WARNER SUBDIVISION

The Northeast Quarter of the Northwest Quarter of Section 16, Range 65 West of the 6th Principal Meridian, El Paso, State of Colorado
 Sheet 1 of 3

16. Warner Subdivision Cover Sheet Project No. 2019092 November 09, 2020 Sheet 1 of 3

Warner Subdivision
 Boundary Solution
 Project No. 2019092
 November 09, 2020
 Sheet 2 of 3

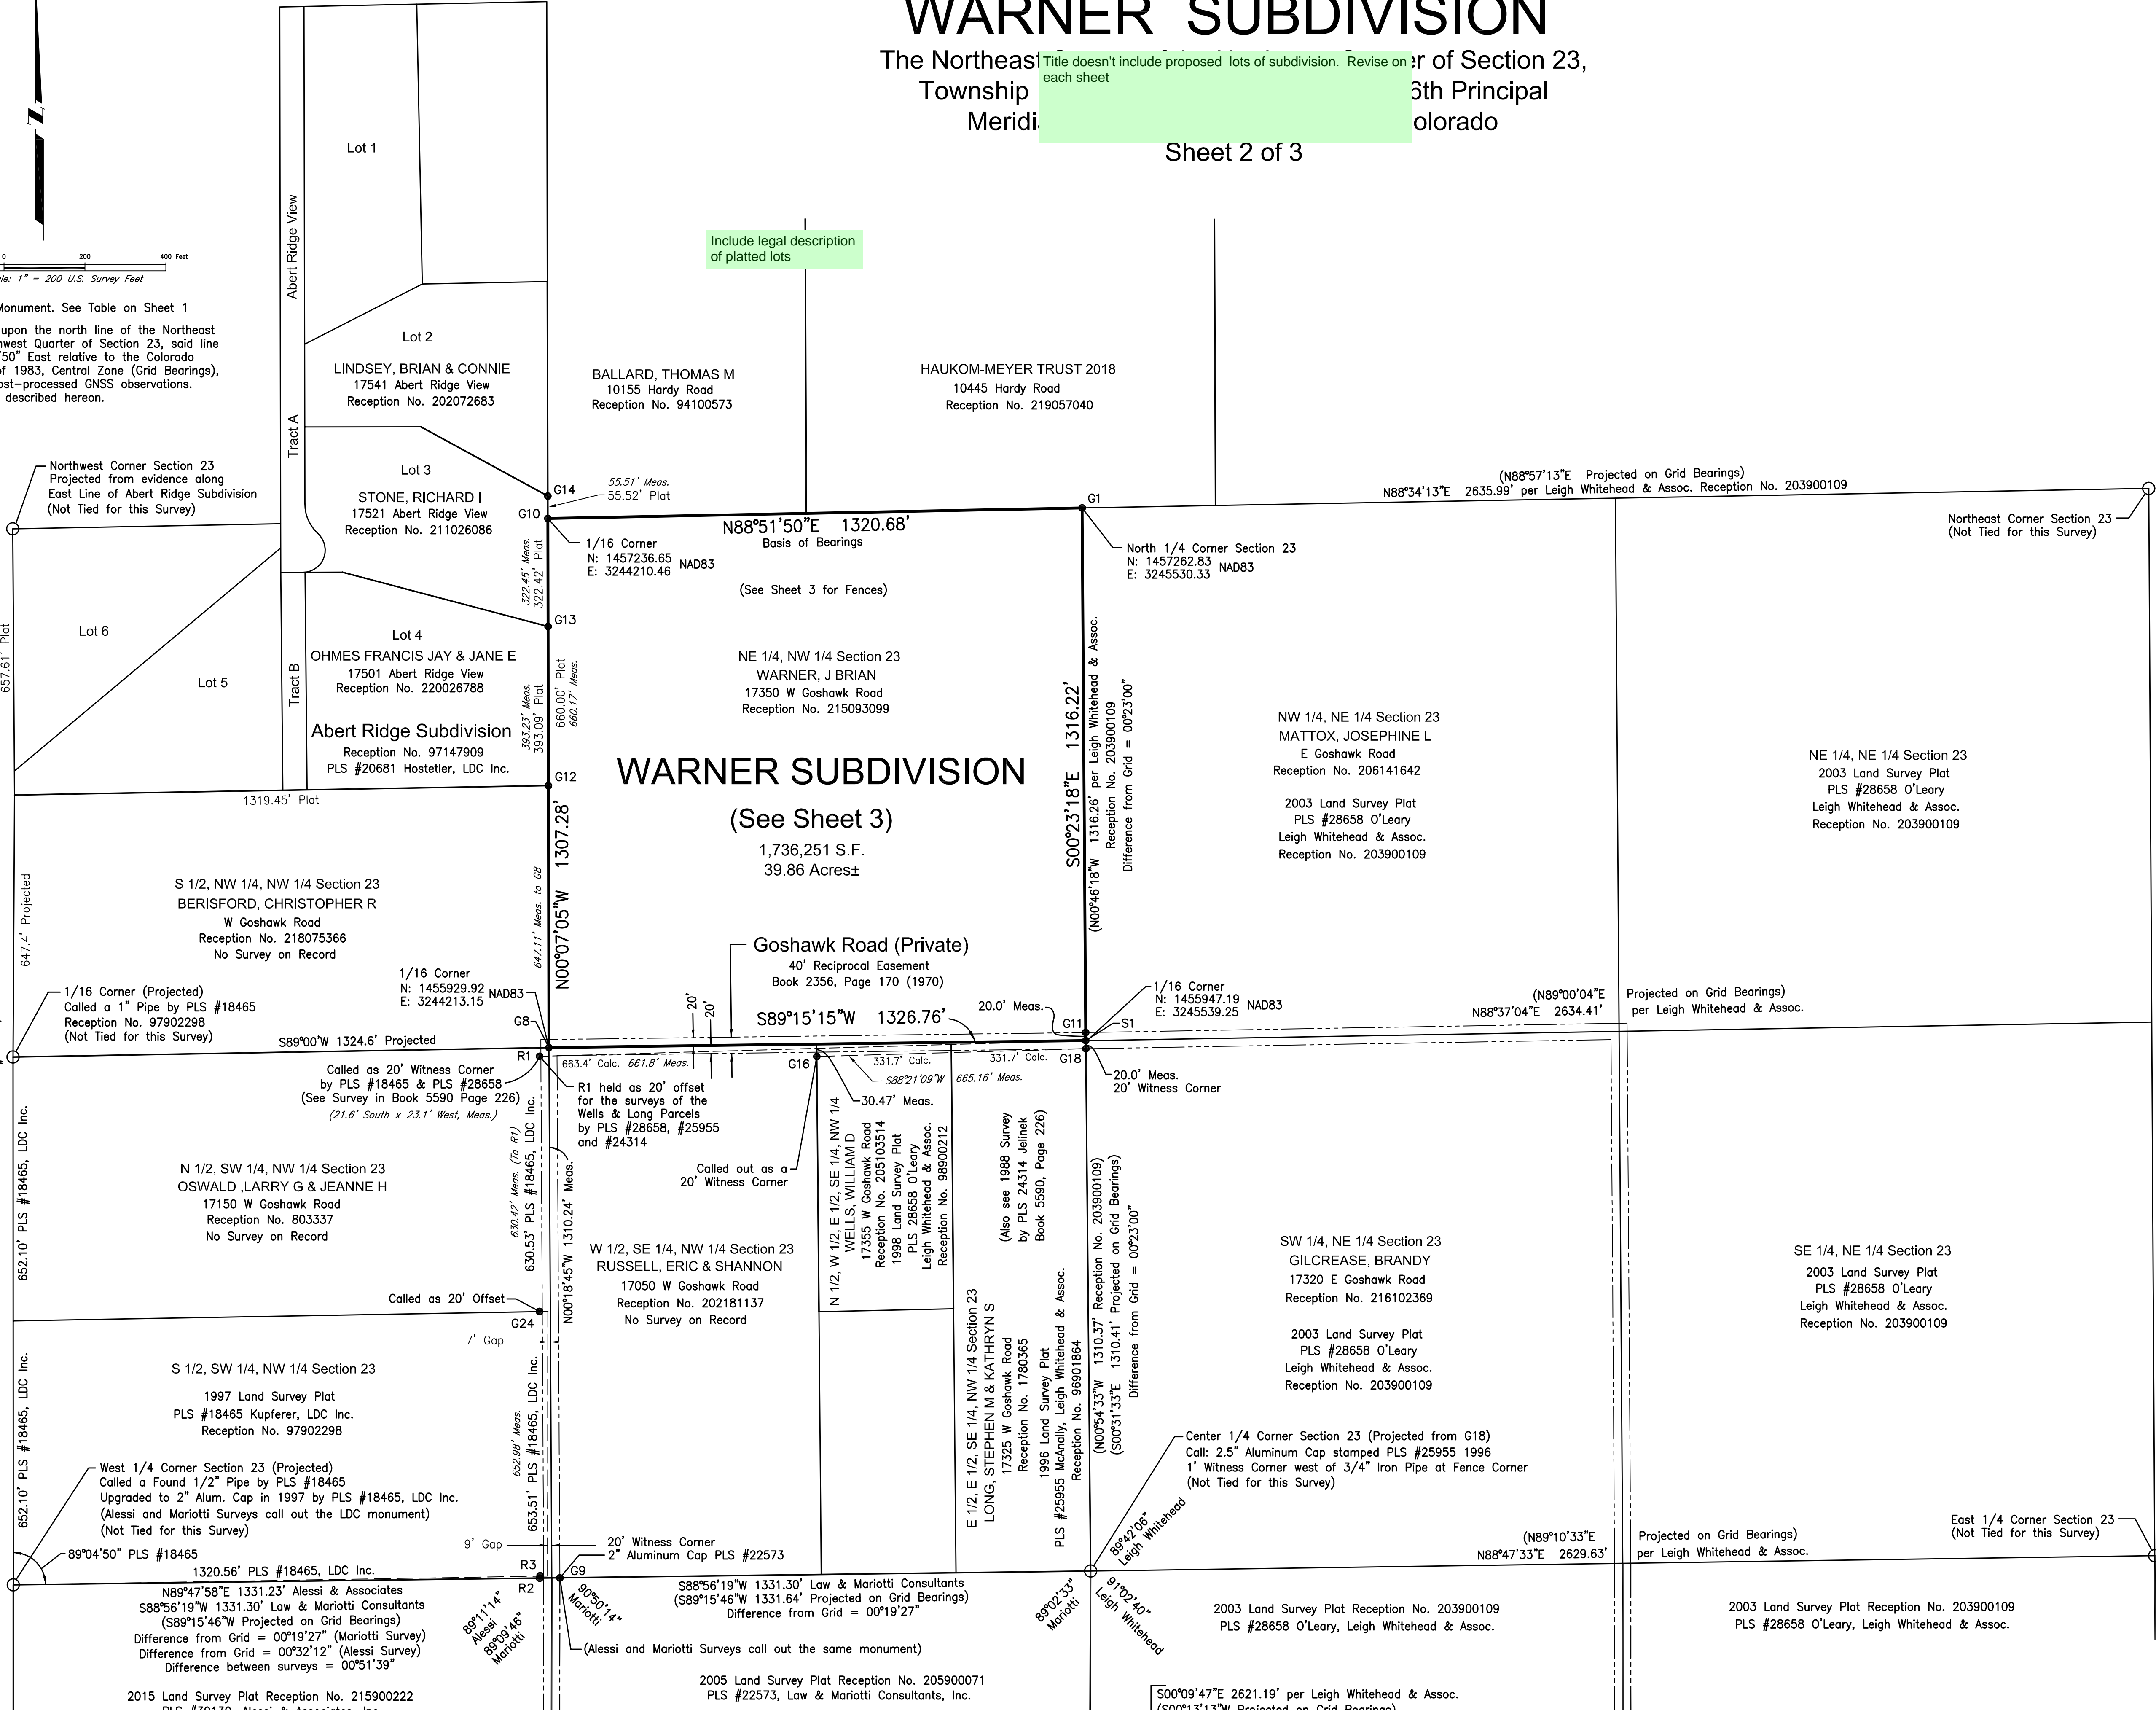
The Northeast Township Meridian
 Title doesn't include proposed lots of subdivision. Revise on north of Section 23, each sheet
 3rd Principal Meridian Colorado

Include legal description of platted lots

Remove.
